Meeting: Traffic Management Meeting

Subject: Park Street, Woburn

Proposed Traffic Calming and 20mph Speed Limit

Summary: To consider objections received as a result of the public consultation on a proposal to construct traffic calming on the C100 road Park Street Woburn and implement a 20mph speed limit.

Drawing Title:
**PROPOSED 20MPH
 SPEED LIMIT**

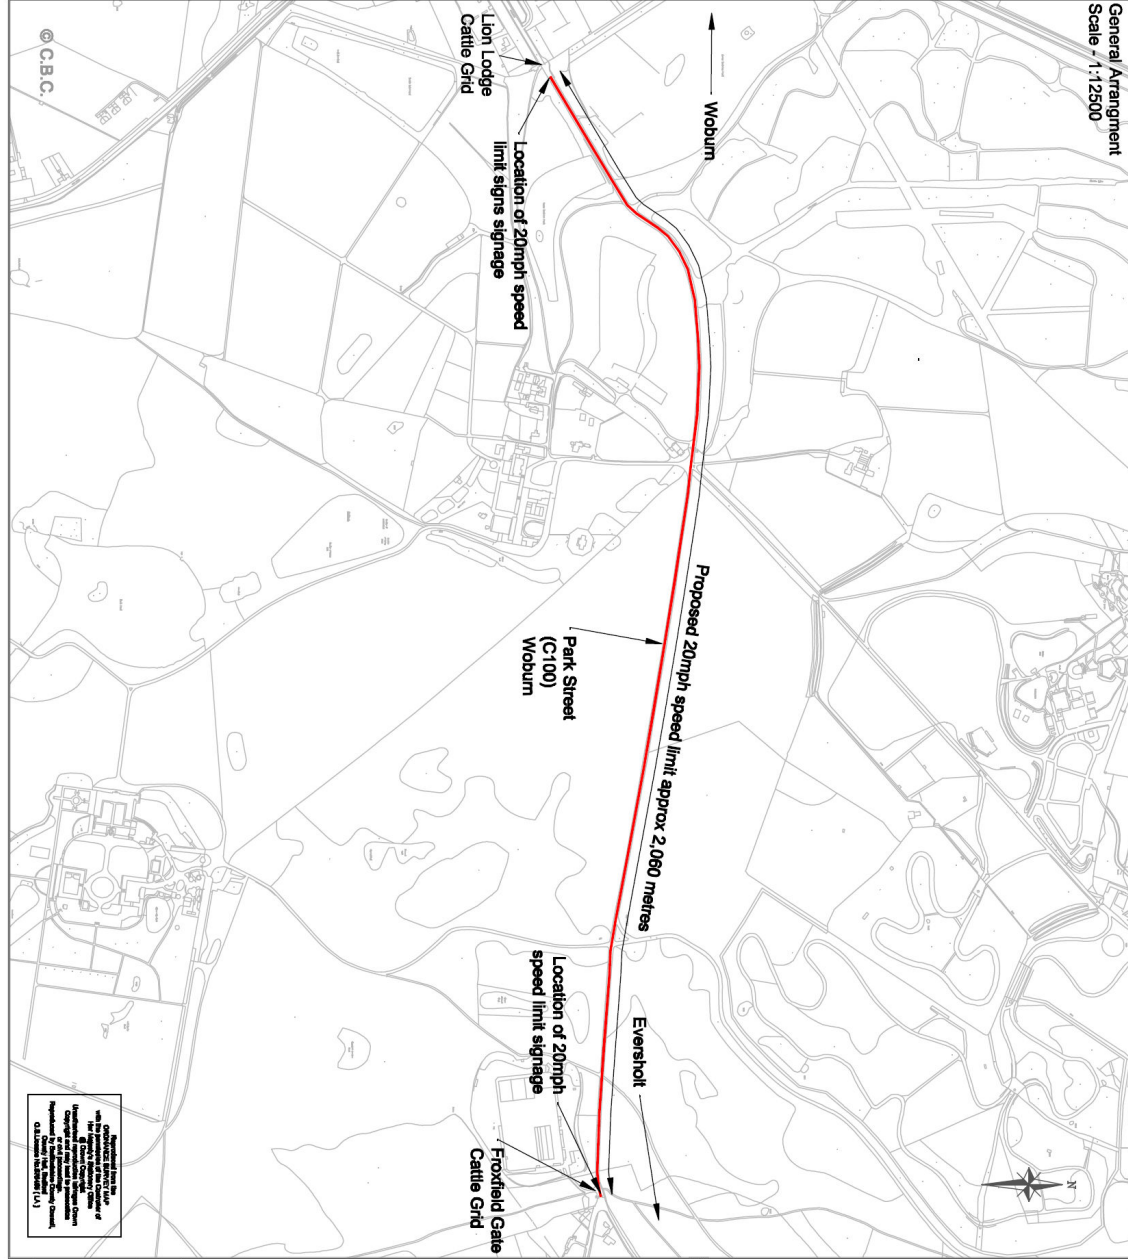
The current 30 mph speed restriction would appear to be appropriate for the type of road, but would benefit from a form of traffic calming to cause compliance as presently a weekly average of 22% are travelling at 35 mph or above, this however does not appear to be an option with the absence of a system of street lighting.

The installing of a 20 mph speed restriction with the proposed supporting traffic calming would not have a significant effect on Police response times to incidents, although consideration has to be given to the potential increase in demands for speed enforcement, road safety measures and other demands that may be made from neighbouring communities, resulting from motorists choosing to use an alternative route avoiding the lower speed limit and calming measures.

Not being aware of the reason for the proposal, or why the proposal has been identified as the most suitable, there would not be an objection from this authority to the 20 mph speed limit supported by road humps to cause compliance of the restriction. It would be requested that a provision is made for the traffic to monitored in the villages of Eversholt and Ridgmont and should there be a significant increase that generates evidenced complaints, appropriate road safety measures be implemented.

Drawing Title:
**TRAFFIC REGULATION ORDER
 ROAD HUMPS**

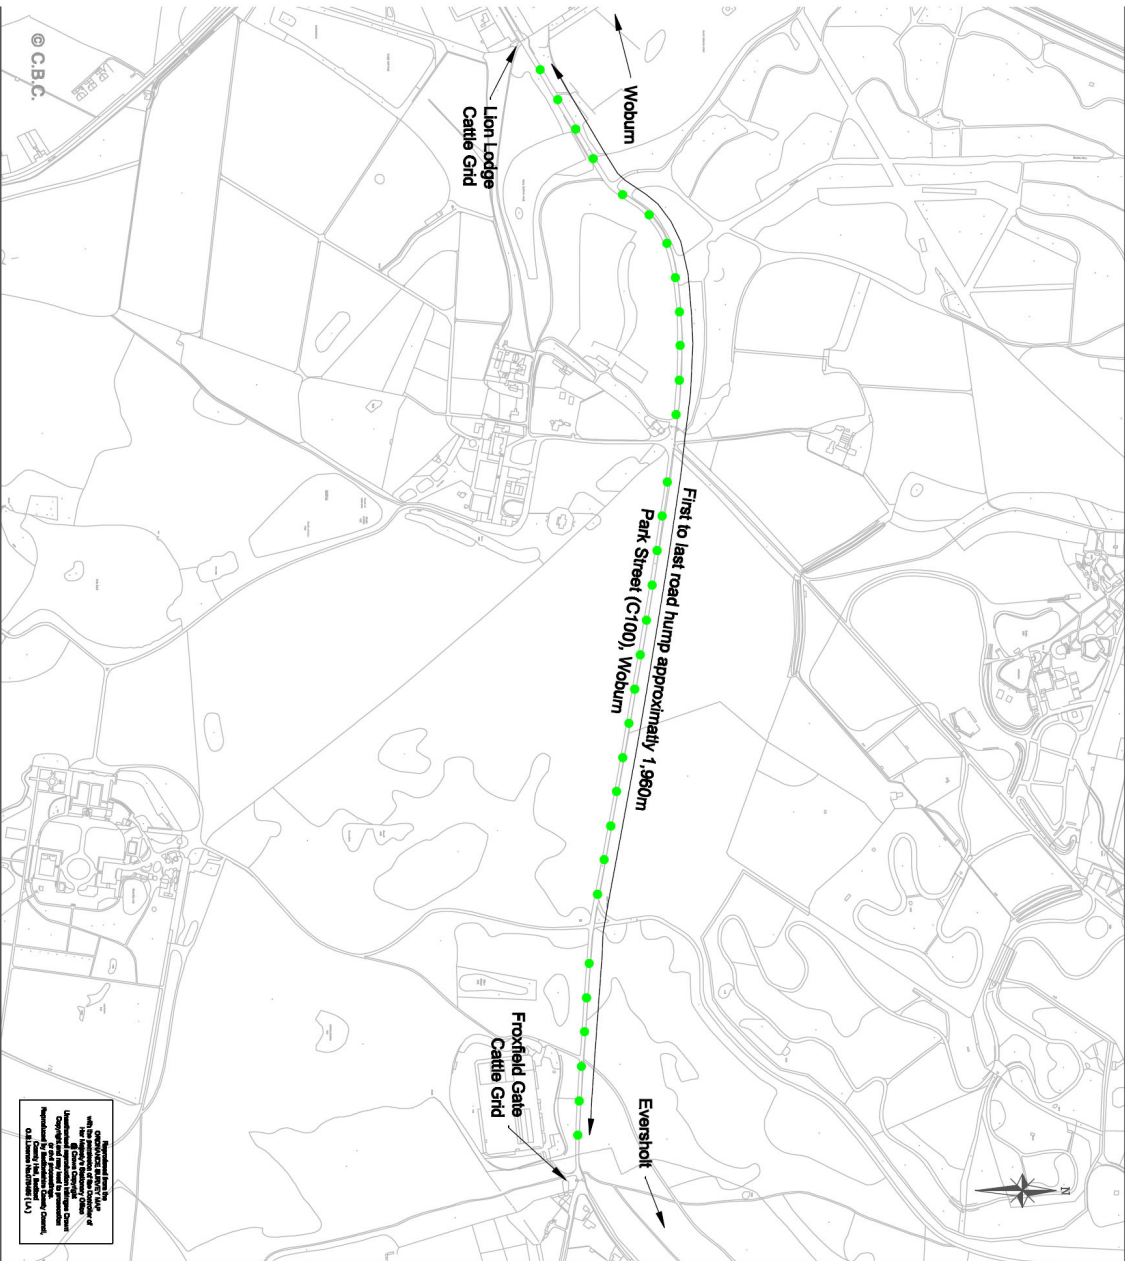
I object to the proposed Road Humps - Park Street (C100) Woburn and 20 miles an hour speed limit on two grounds.

1. The C100 currently has a 30 mile an hour speed limit and three cattle grids which are sufficient to slow the traffic to a safe speed applicable for the road's environment, traffic volume and size. The road is straight with a good view of potential obstructions, such as deer, there is no need for further restrictions.

2. With the proposed restrictions in place, I believe that vehicles would try alternative routes from Woburn such as though Milton Bryan then into Eversholt, a route comprising of even smaller country roads, when compared to the C100, which are not suitable for vans or larger vehicles and would be a danger for such a volume of traffic; or though Ridgmont, which has just had a bypass to negate the its traffic problems, though to Eversholt, again causing dangerous traffic conditions though single lane roads such as Berry End.

I wish to object to the proposed road humps being installed on Folk Street, Woburn, also known as the C100 and the reduction in the speed limit.

This is straight road with, apart from one small incline, excellent visibility. The road has three cattle grids which indicate livestock is roaming and I feel that a 30mph limit, which is clearly signposted is relevant to the road.

I am concerned that if over thirty speed humps are installed, drivers will find alternative routes. These will take them through Milton Bryan and Ridgmont. Both these routes will increase the traffic through Evesholt. I walk my two children to and from school. There is no pavement and the traffic does not generally

I object to the proposal to put speed humps through Woburn Deer park on the C100 from Lion Lodge to Froxfield Gate for the following reasons:-

- The difficulty emergency vehicles will have to reach Eversholt
- The difficulty of effective gritting of the C100 in winter
- The environmental consequences on single track village roads by increased traffic avoiding the speed humps. This rerouting of traffic may be an objective of Bedford Estates but does not help the pedestrian safety, air pollution and noise on our narrow village roads.
- The cost of lighting and upkeep from public funds via the Council
- The aesthetics of chevron markings etc. through an area of outstanding natural beauty
- I live in Hills End Eversholt and we already suffer from cars and lorries using our road as a cut through, and this will get much worse
- I work locally and use the C100 regularly - the effect on my car if speed humps are introduced will be costly.

I am writing to formerly object to the proposal to the installation of numerous speed humps through Woburn Park as this excessive number will make driving impossible endanger the access of emergency vehicles and therefore endanger our lives in the village of Eversholt and mean a detour to get to Woburn.

This Association objects to the installation of 31 speed bumps because it will see an increase in traffic using Berry End Road between Eversholt and Ridgmont. This will increase the likelihood of a traffic accident between motor vehicles and walkers travelling between Eversholt Footpath Nos 12, 16 and 17 along what is a narrow and winding section of road on which cars are all too often driven at too fast a speed.

**Proposed Traffic Regulation Order – Road Humps Park Street Woburn
BH/305228/DR/1200/004**

May I start by saying that we are not writing to object to these proposals to impose a 20 mph speed limit and put in road humps through the Park. We are in favour - please see my exchange of correspondence with The Duke (then Lord Howland), in 2000.

We are however writing to ask you to consider also putting 'road humps' from the village centre along Park Street to the Lions Gate and refurbishing the footpaths, as part of this proposal to enhance the safety of the residents of Park Street and the many members of the public who walk to and from the Park from the Public Car Park, opposite our cul de sac.

16. in response to the objections it should be noted that:
- Speeds are currently consistently above the speed limit
 - There may be an element of displacement but this is difficult to determine and given the already low volumes of vehicles is likely to be of fairly minimal impact.

- No response has been received from the emergency services
 - Traffic calming is negotiable by gritting lorries but may cause some difficulties for snowploughs in the unlikely event that becomes necessary.

- There may indeed be a small environmental penalty if vehicles divert but this may be offset by other vehicles being driven more slowly
 - The cost of maintenance is likely to be slightly increased as additional road markings will require maintenance but this is minimal.

- Aesthetics are subjective.
 - Road humps traversed at the correct speed are unlikely to have a significant effect on the condition of vehicles.
 - Road safety on other roads would need to be assessed before any opinion could be offered.
